Nuclear Energy Institute
International Event Scale Meeting
June 25, 2003

On January 14, 2002, the Nuclear Regulatory Commission (NRC) issued Regulatory Issue Summary (RIS) 2002-01, "Changes to NRC Participation in the International Nuclear Event Scale (INES)". On July 26, 2002, the Nuclear Energy Institute (NEI) met with the NRC staff in a public meeting in Rockville, Maryland to discuss the INES program changes and provide recommendations for changes in the implementation of the program based on potential unintended consequences.

PWR Typical Technical Specification Activity Example Curve

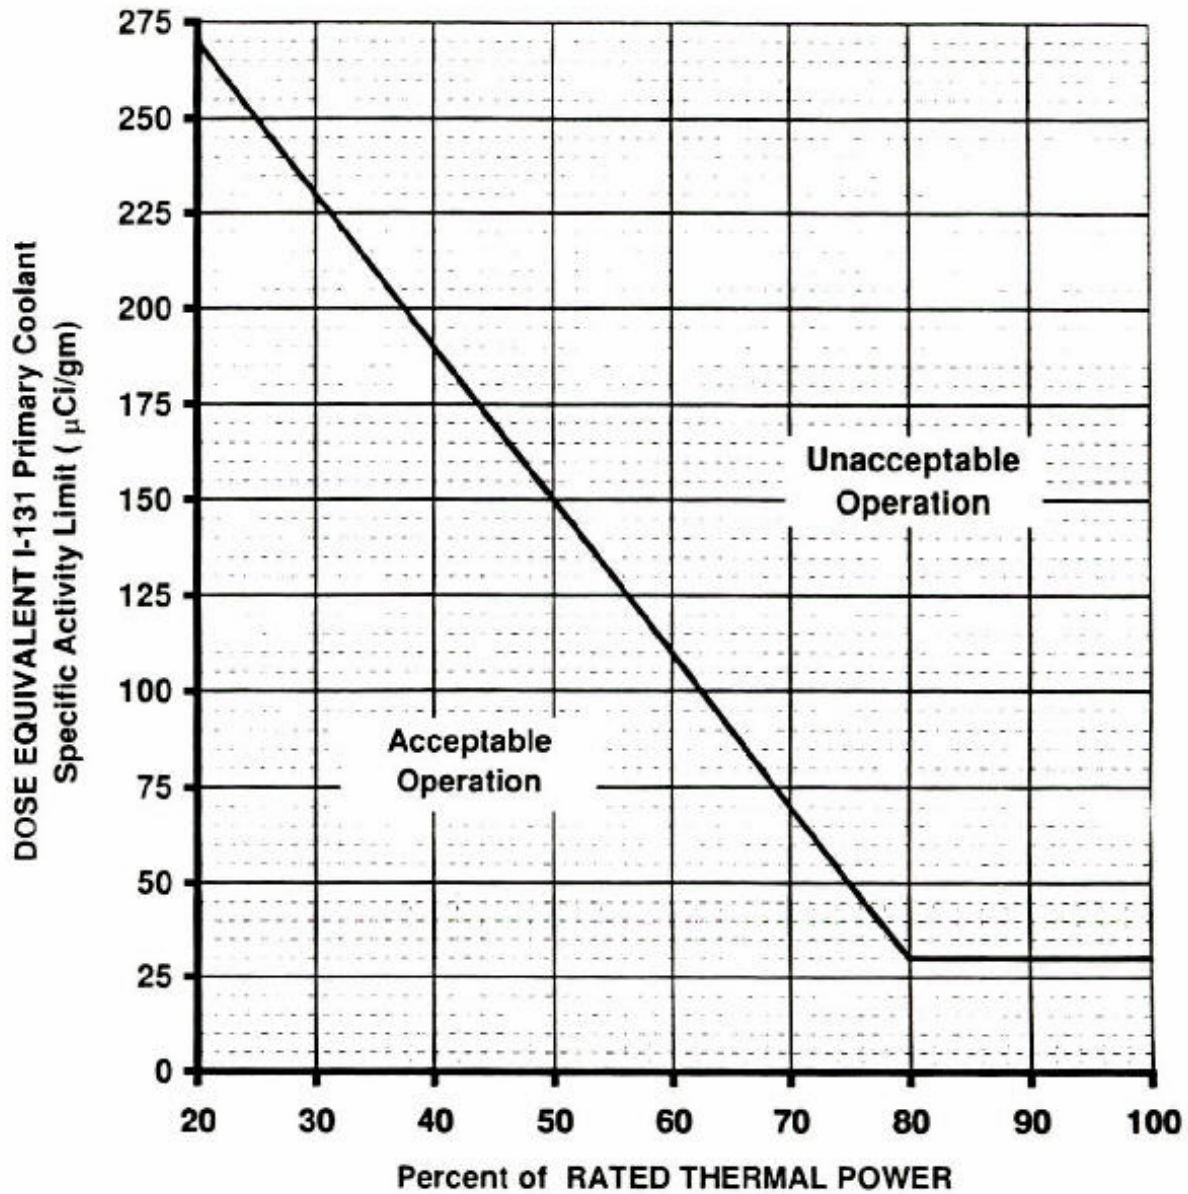
In most US industry events involving fuel clad damage over the last 20 years, RCS activity has remained within the Technical Specification LCO range with I-131 coolant activity remaining in the acceptable operating range of the Technical Specification activity limit curve (an example typical PWR curve is attached). Using a literal interpretation of the INES criteria these events could have been misinterpreted, especially for BWR events, and end up being over-classified using On-Site impact criteria instead of Defense-in-Depth impact criteria. The following supporting details assume that "barrier damage" or "core damage" is synonymous with "clad damage" (i.e., this is not an overheat/melt condition):

DEI elevated into the Unacceptable Operation region of the Technical Specification transient limit requiring shutdown.

DEI elevated into the Allowable Operation region of the Technical Specification transient limit for greater than the specified action statement time limit requiring shutdown.

DEI elevated out of normal Technical Specification operating limit but returned to within normal operating limit within specified action statement time limit with no shutdown required
